V2_Drainage Report - Final_comments.pdf Markup Summary

ELK VIEW ESTATES
CONSTRUCTION DRAWINGS

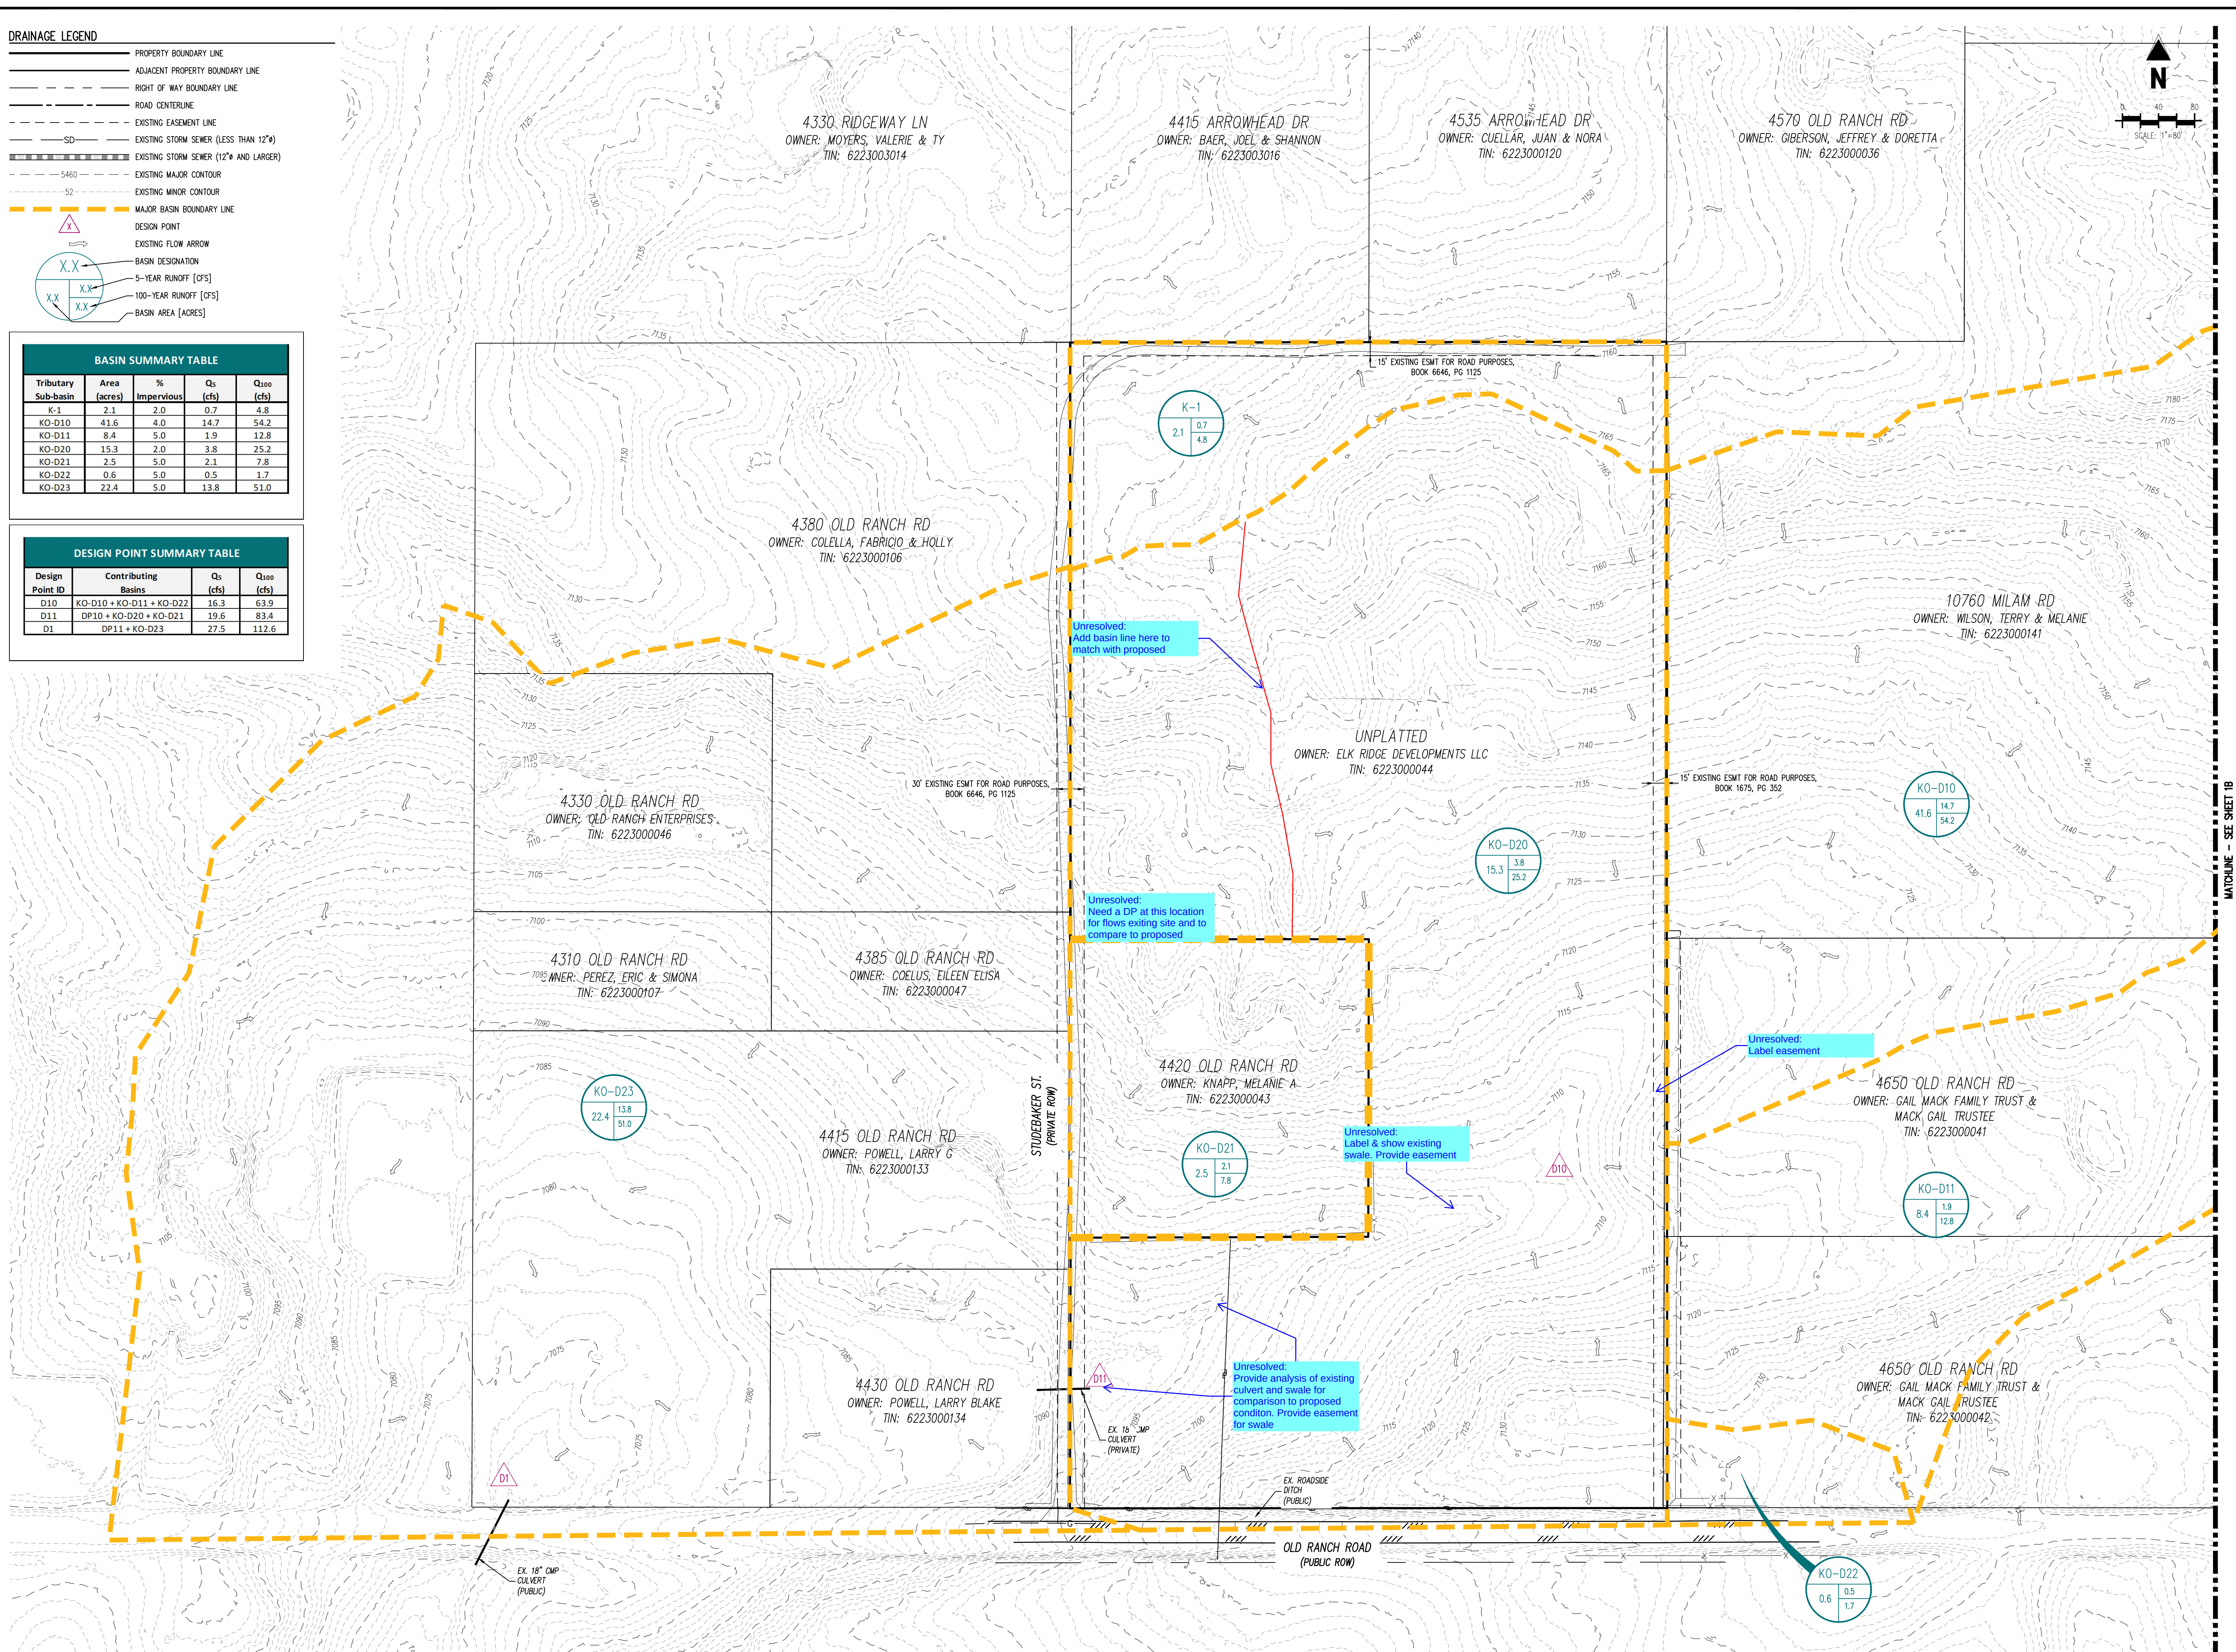
Unresolved:
Label & show existing swale. Provide easement

Unresolved:
Provide analysis of existing culvert and swale for comparison to proposed condition. Provide easement for swale

Unresolved:
Add basin line here to match with proposed

Unresolved:
Label easement

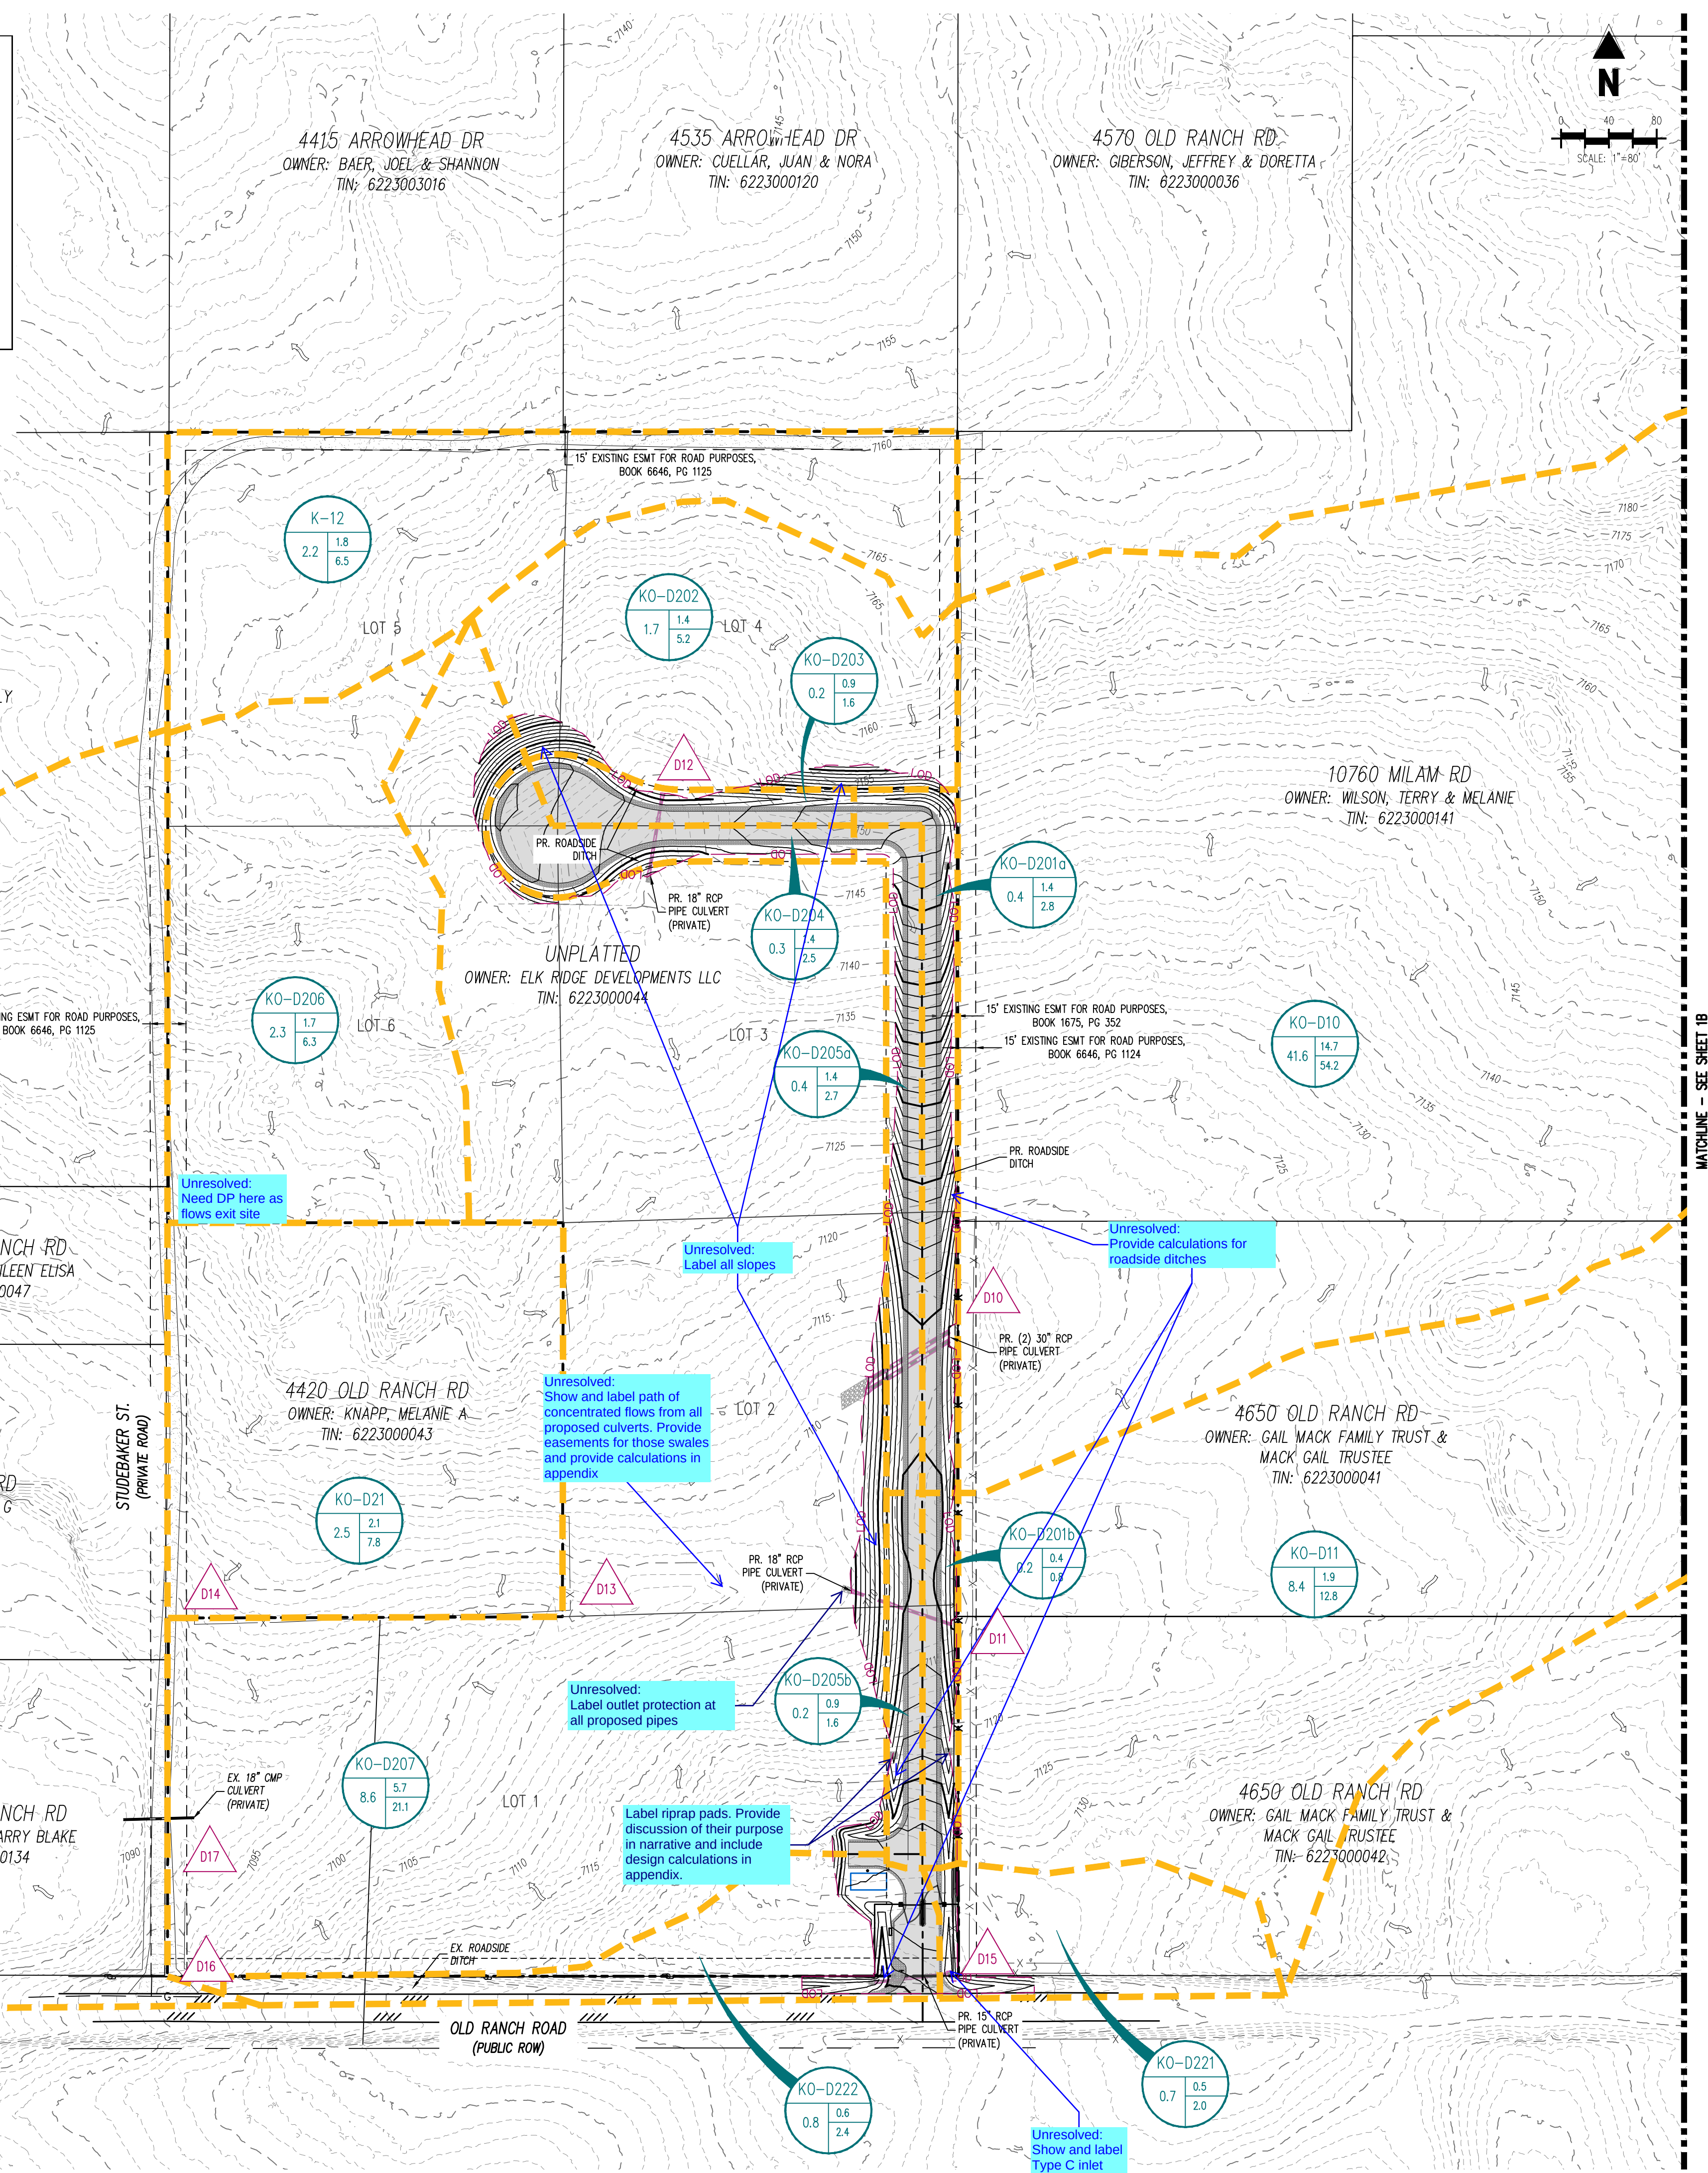
Unresolved:
Label all slopes

Unresolved:
Provide calculations for roadside ditches

Unresolved:
Label outlet protection at all proposed pipes

Unresolved:
Show and label path of concentrated flows from all proposed culverts. Provide easements for those swales and provide calculations in appendix

Unresolved:
Show and label Type C inlet

Label riprap pads. Provide discussion of their purpose in narrative and include design calculations in appendix.
